D E S I G N
R E V I E W
C O M M I T T E E
S T A F F R E P O R T

2587 Telegraph Avenue

FINAL DESIGN REVIEW

Design Review #DRCF2024-0005 to demolish a two-story retail building and construct an eight-story (95-foot) 112,562 square-foot mixed-use residential building with 52 dwelling units, including six (6) Very Low-Income Density Bonus Units, 2,903 square feet of ground floor commercial, and 73 long term and six (6) short term bicycle parking spaces.

FINAL DRC REVIEW SUBMITTAL
OCTOBER 21, 2024

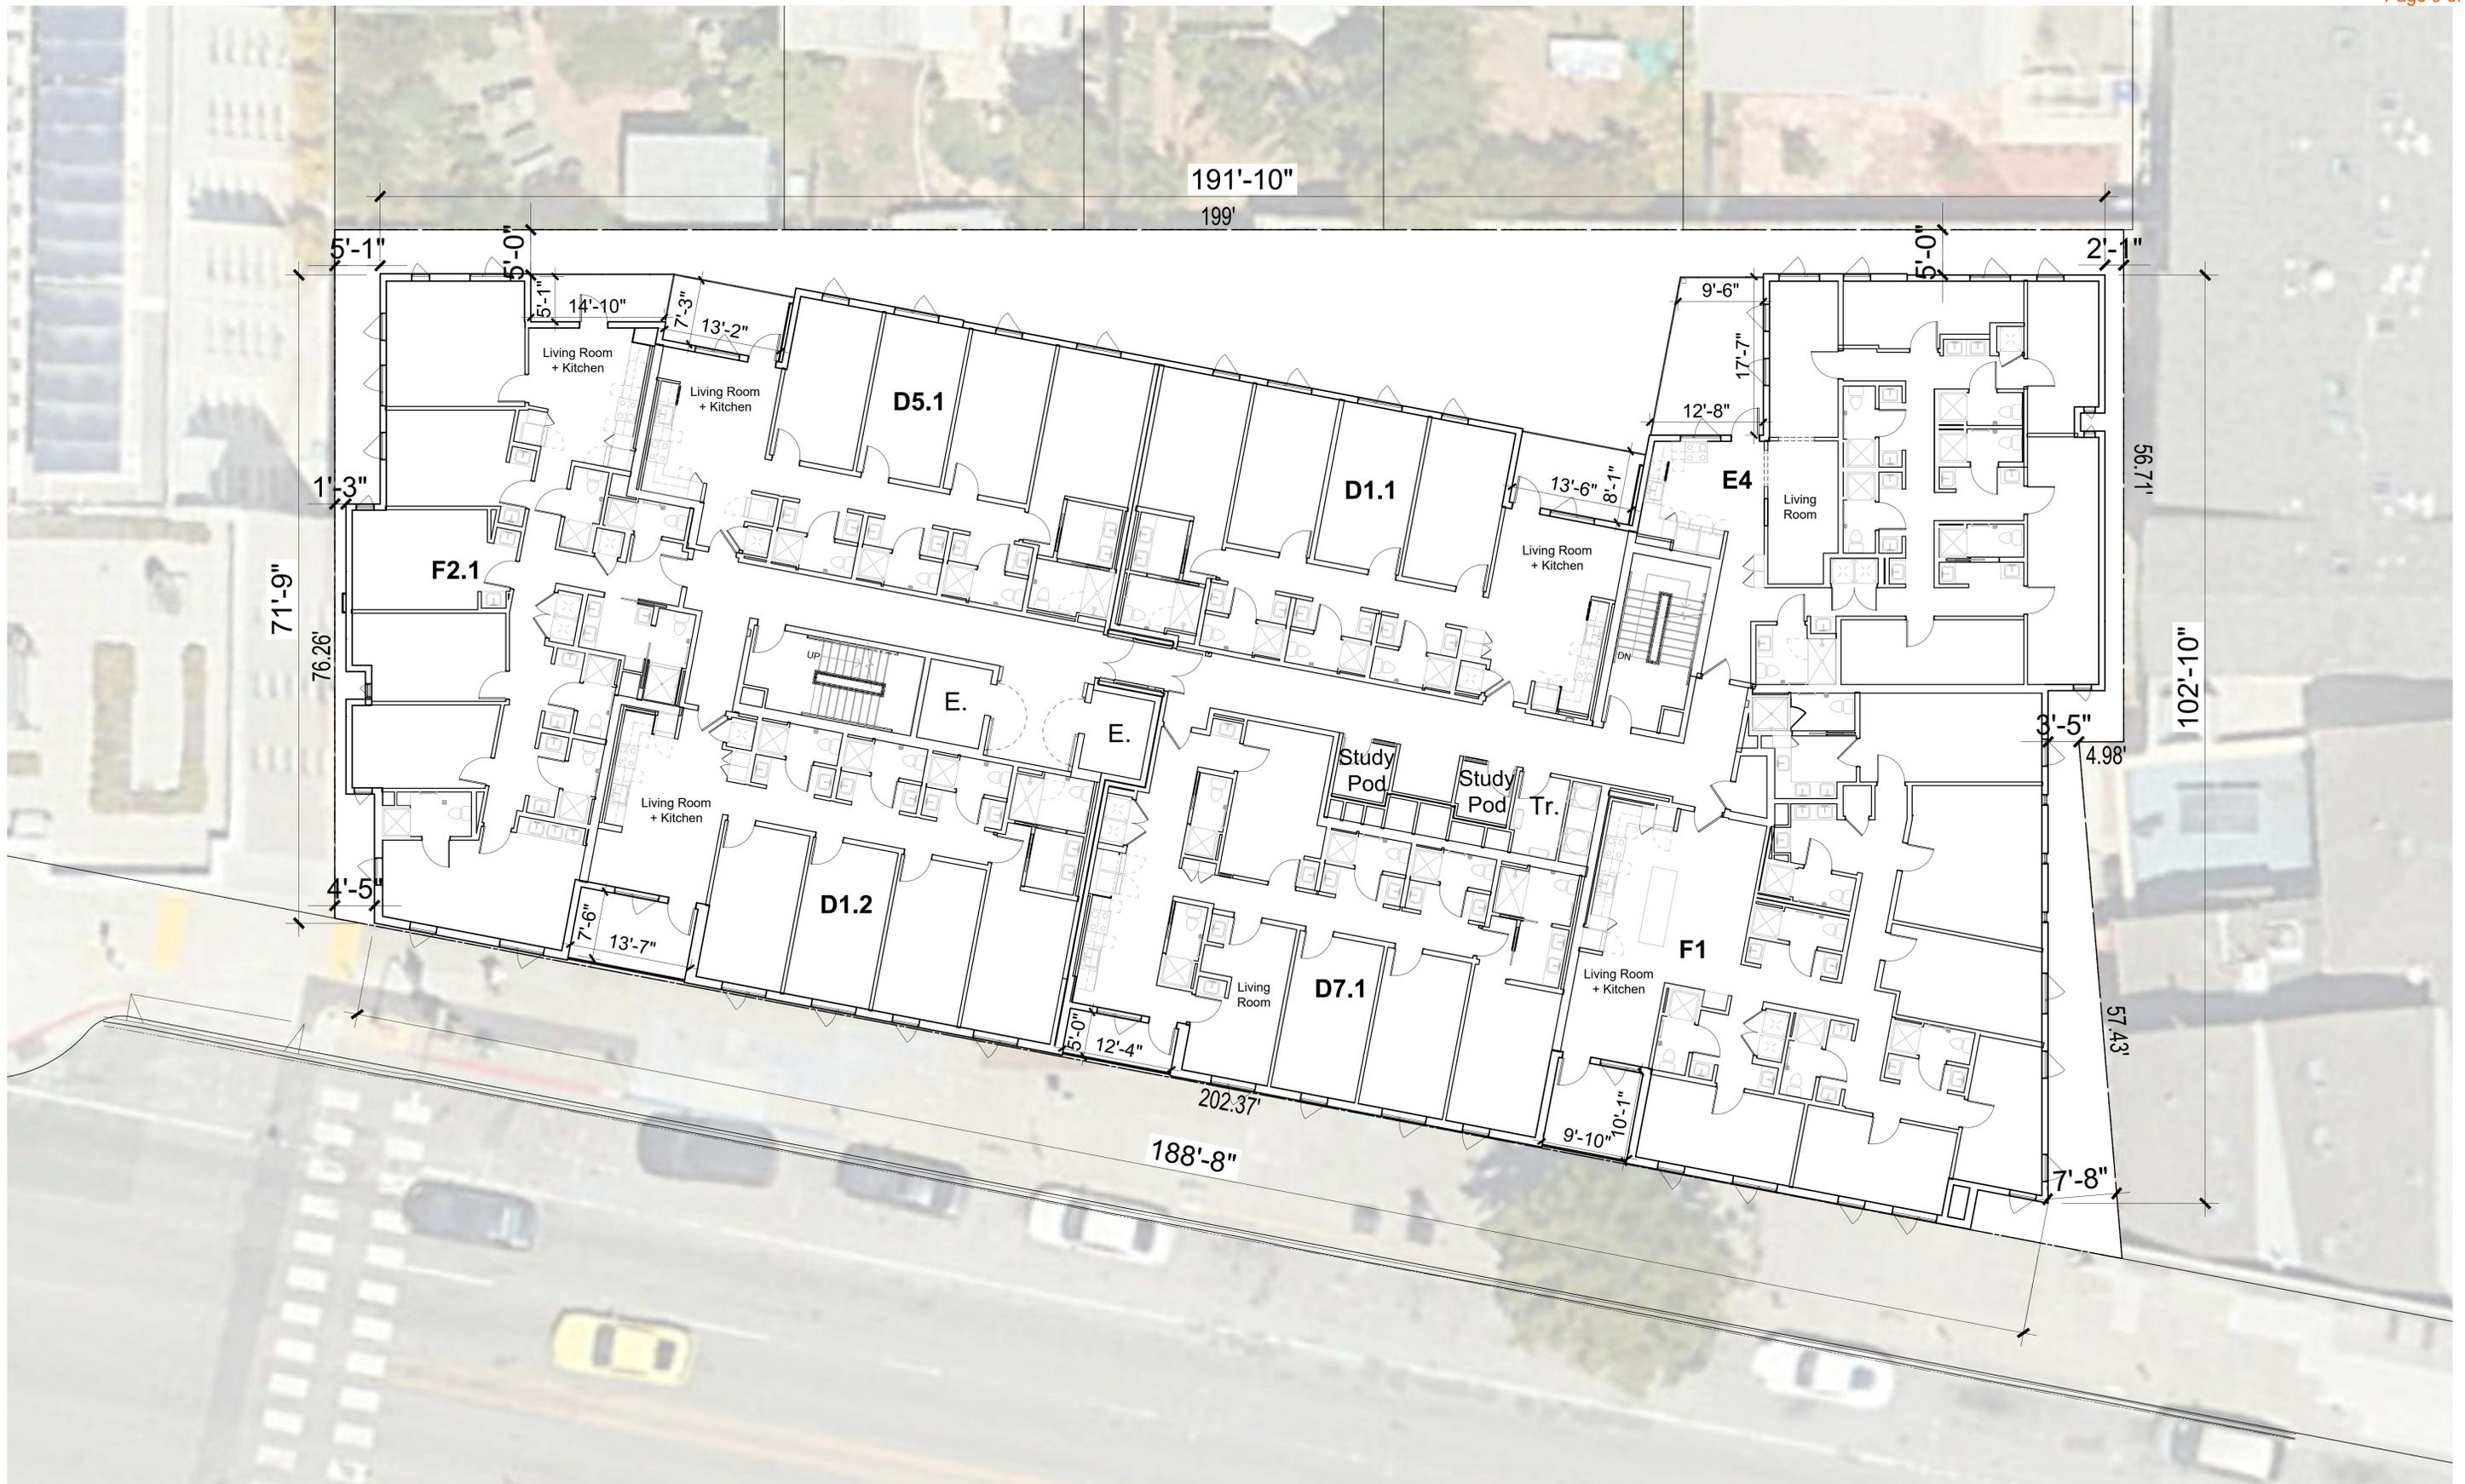
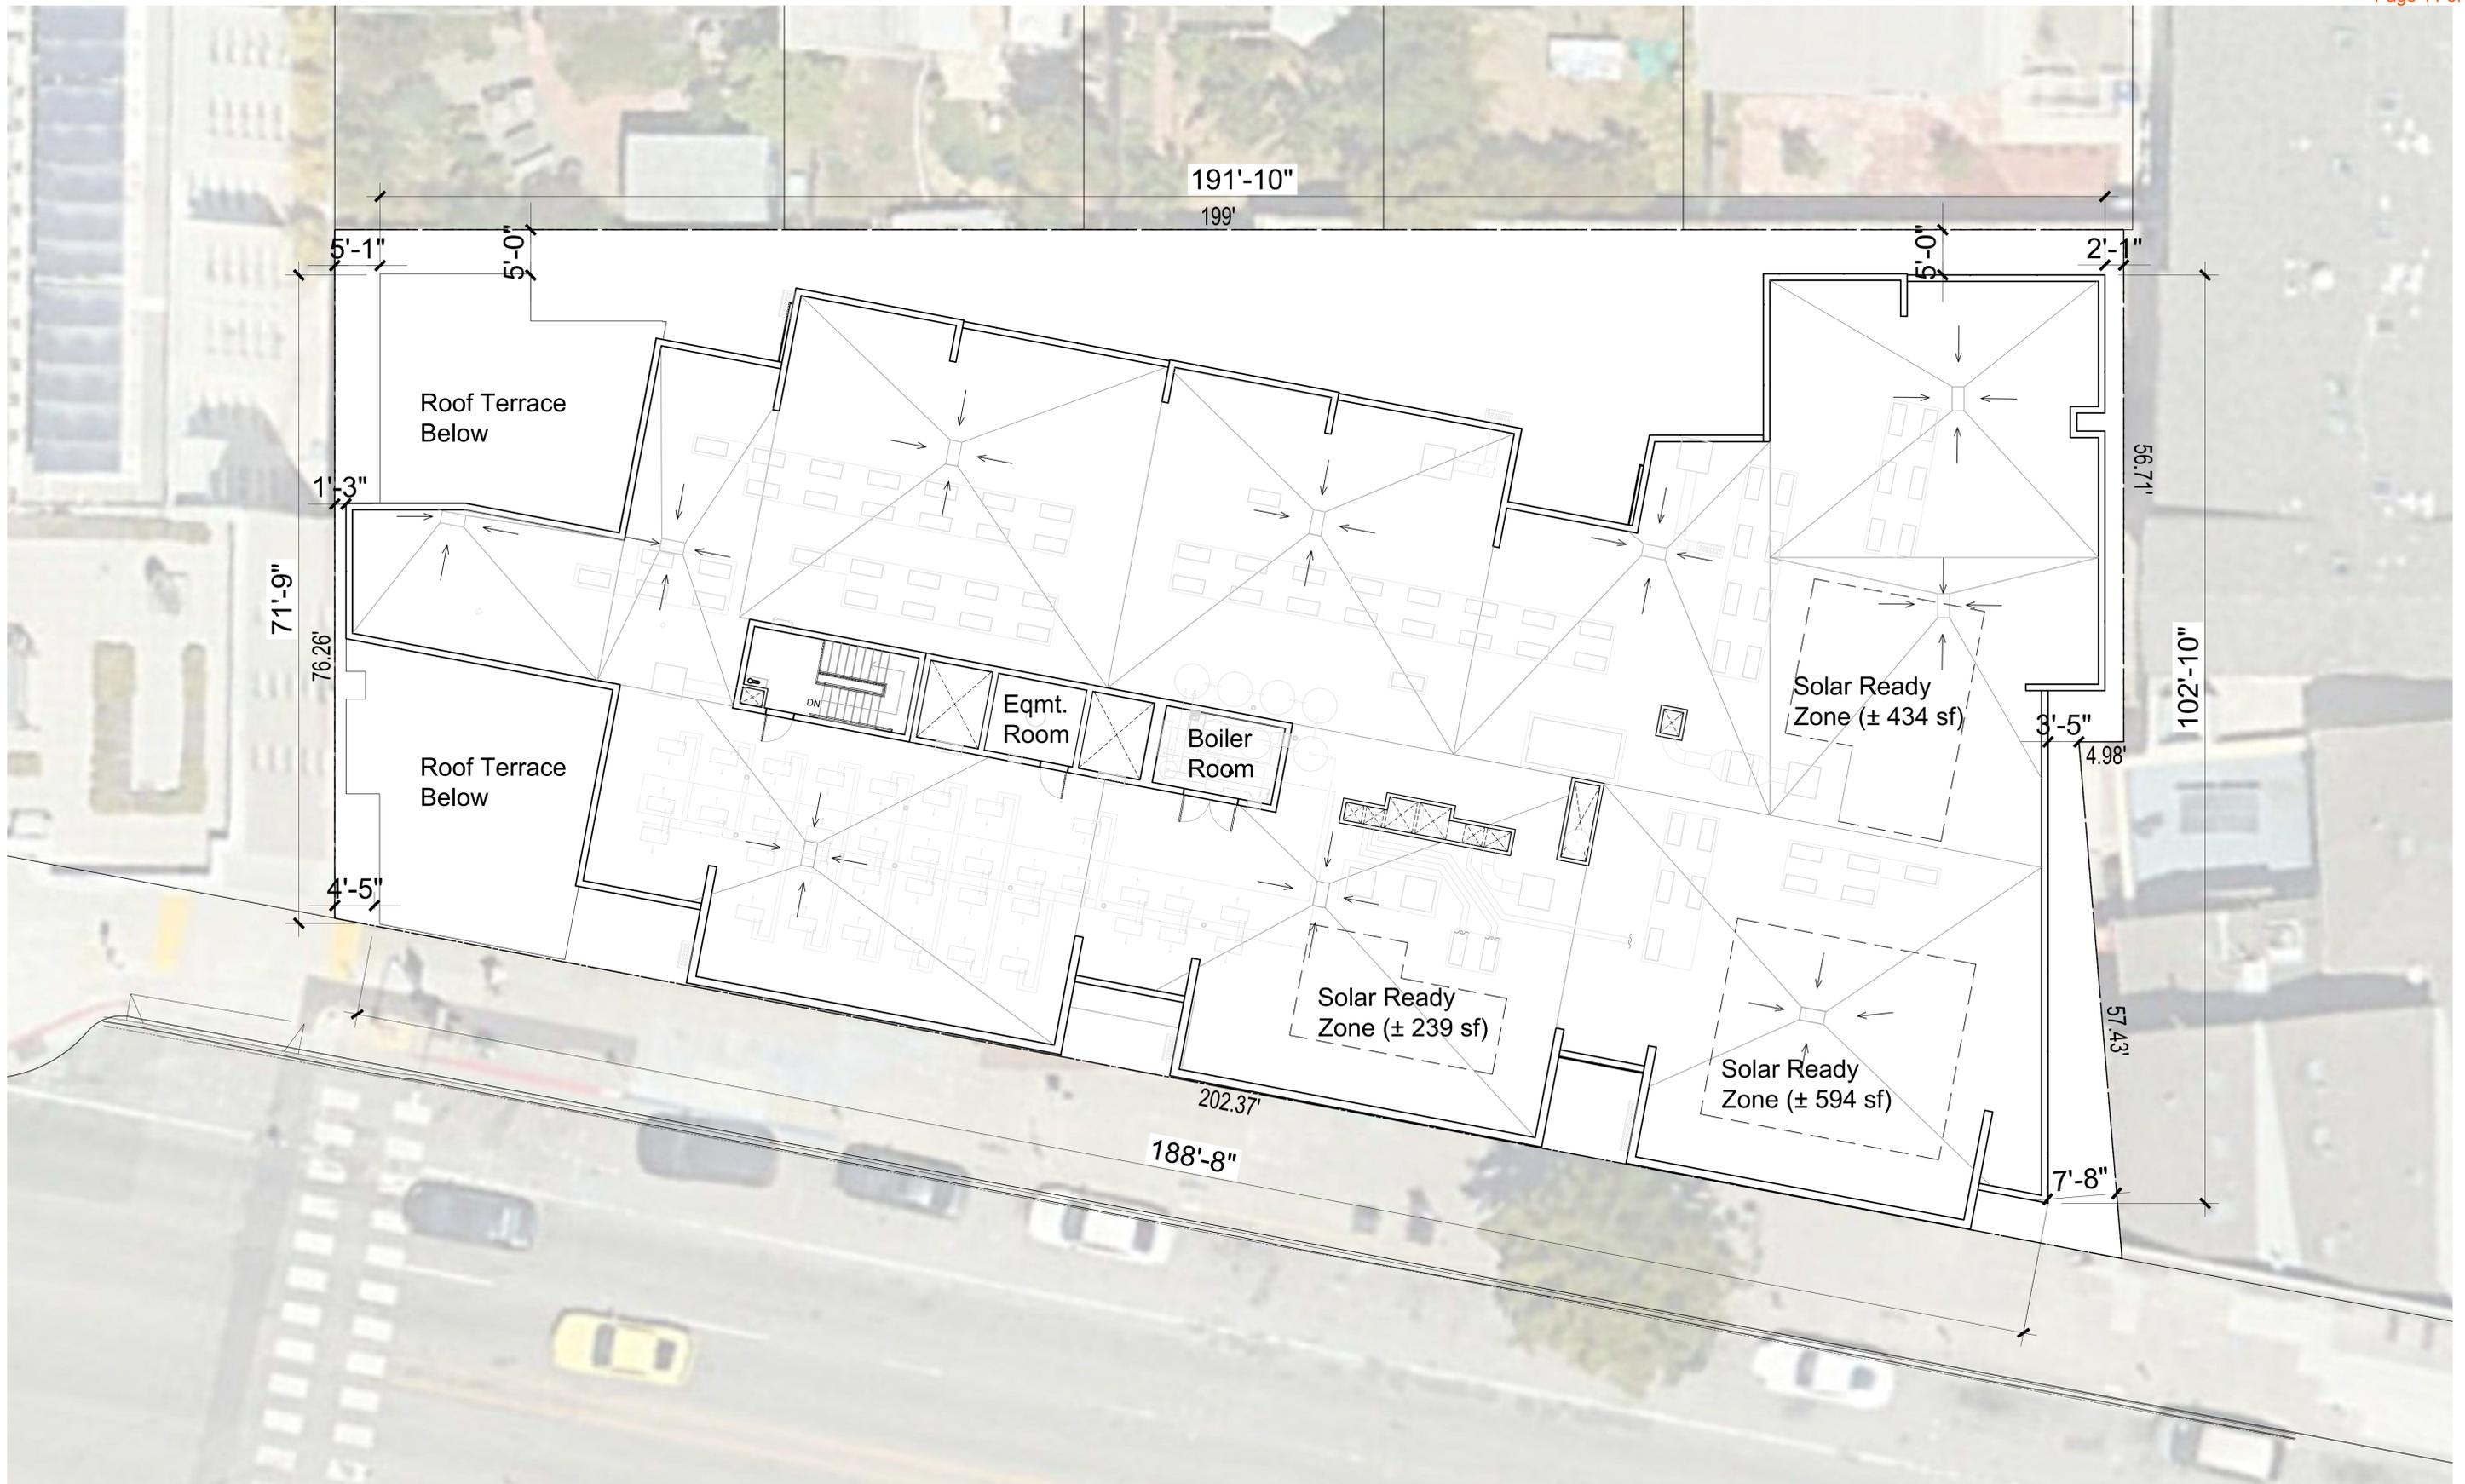
3	<i>Visually raise the ground floor, or at least bring study of how this building transitions with adjacent structures.</i>	A0.3, A2.0	The ground floor has been pulled forward to reduce the previously proposed 4ft-5ft overhang. Now the 12" vertical jog mitigates the feeling of being "compressed" as it relates to adjacent structures. To visually achieve a two-story ground floor expression, the wood material, window modules, and architectural detailing are consistent with the ground floor.
4	<i>Study the first floor and accurately show the grade change in the elevations. Call out the height to the bays.</i>	A5.8	The building overhang has been eliminated. With this new revision to the ground floor, the bays have been removed and the proposed grade and heights have been provided.
5	<i>Windows on the west façade should have more logic, but also less repetition.</i>	A0.3, A2.0	The windows on the West façade have been aligned to establish a visual vertical line, creating a sense of order and structure. This alignment provides vertical consistency while still allowing the windows to vary in placement per pair of levels, adding visual movement across the entire façade.

1. Window Sill at Flat Metal Panel (3" = 1'-0")

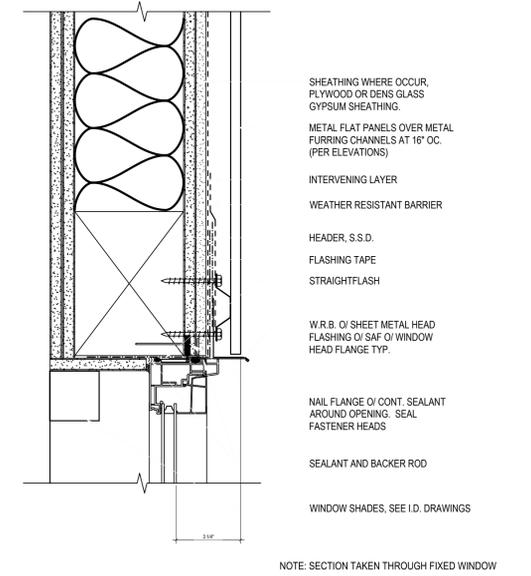
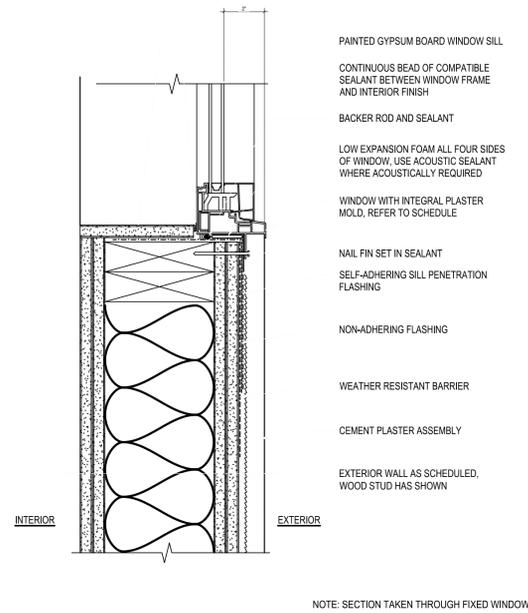
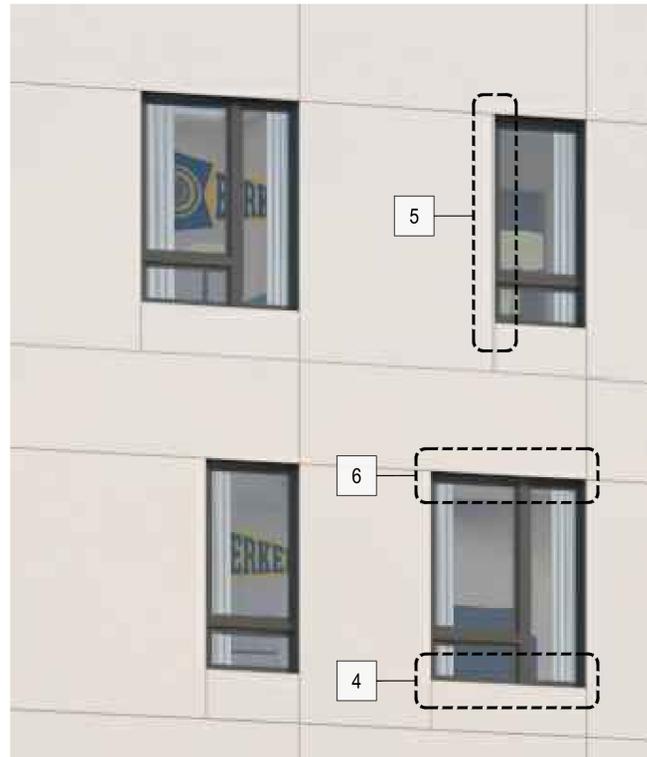
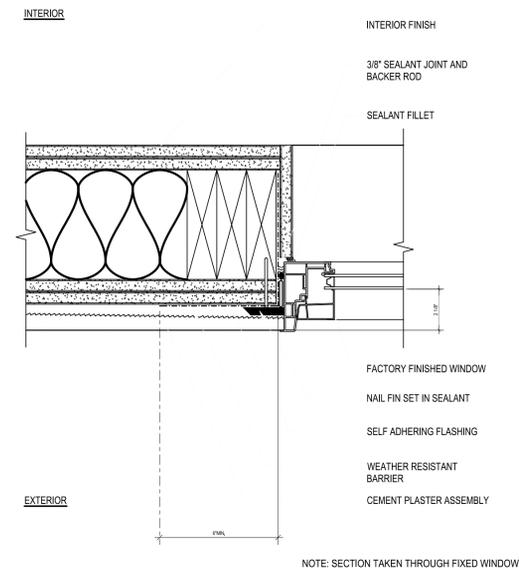
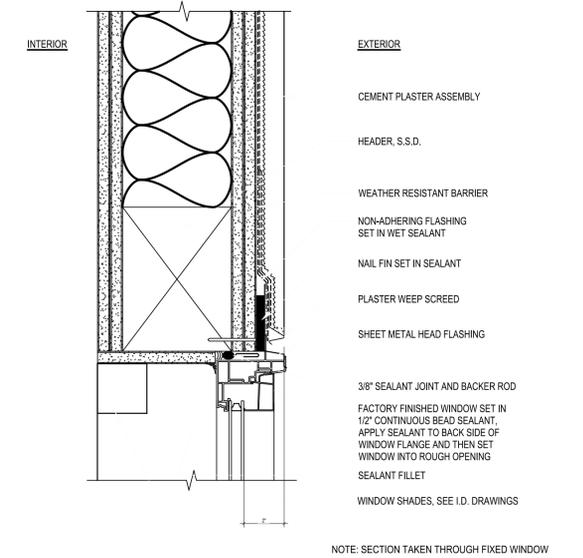
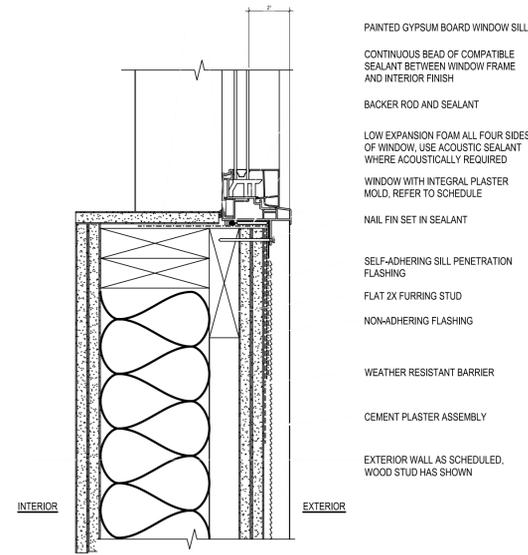
Details Requested for Final DR			
14	<i>Windows</i>	A5.0 - A5.1	Windows are proposed as a black vinyl window to create depth and contrast against the adjacent wall surfaces. Windows in profiled metal panels will exhibit a recess the depth of the rainscreen. Fixed windows in the stucco wall will have a 2" recess from face of finish to face of glazing
15	<i>All exterior details</i>	A5.2 - A5.3	Exterior details have been provided in the DRC plan set. This includes: <i>profiled/flat metal panels, composite panels, and transition details of materials</i>
16	<i>Parapets</i>	A5.4	Parapet details have been provided.
17	<i>Awnings</i>	N/A	There are no awning proposed; awnings have been omitted from the elevations.
18	<i>Railings</i>	A5.5 - A5.6	Railing details have been included. The railings along Telegraph Ave will be glass. The railings along the east façade are 4.5ft tall with an integrated high table to create a physical barrier to the edge. The eastern railing will be a dark wood slat finish with 1" gaps. The finish is consistent with landscaping elements for a holistic design approach.

1. Storefront Sill at Interior Board Form (3" = 1'-0")

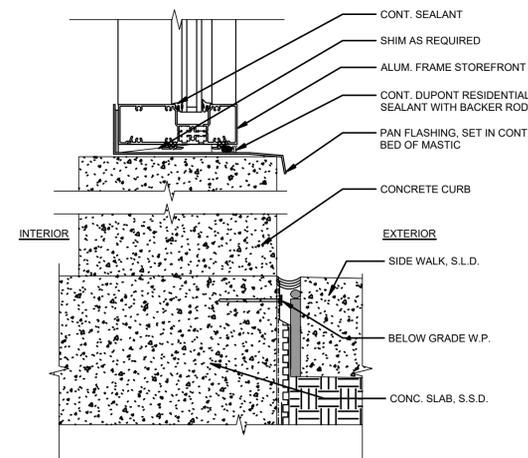
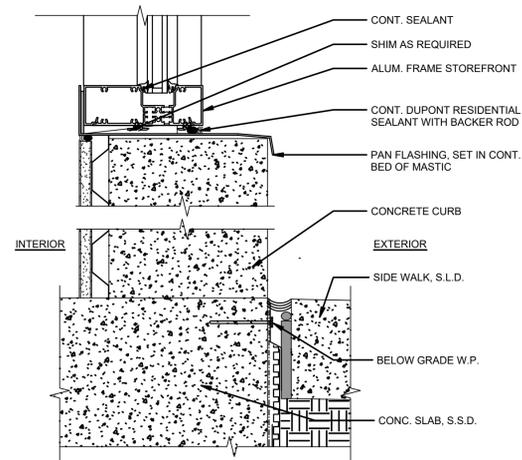
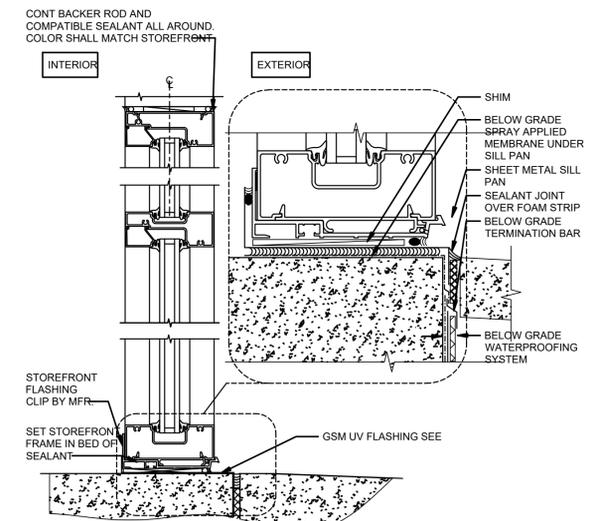
19	<i>Storefront</i>	A5.7 - A5.8	The storefront design draws inspiration from the retail character of the Telegraph Corridor, integrating seamlessly with the area's aesthetic. The two retail storefronts features unique detailing, including different glazing and operation elements. This design approach provides flexibility for various retail tenants and uses.
20	<i>Landscape at Eastern edge</i>	L1.01	Fence detail provided.
21	<i>More specific planting plan</i>	L1.06 - L1.07	Full planting plan provided.
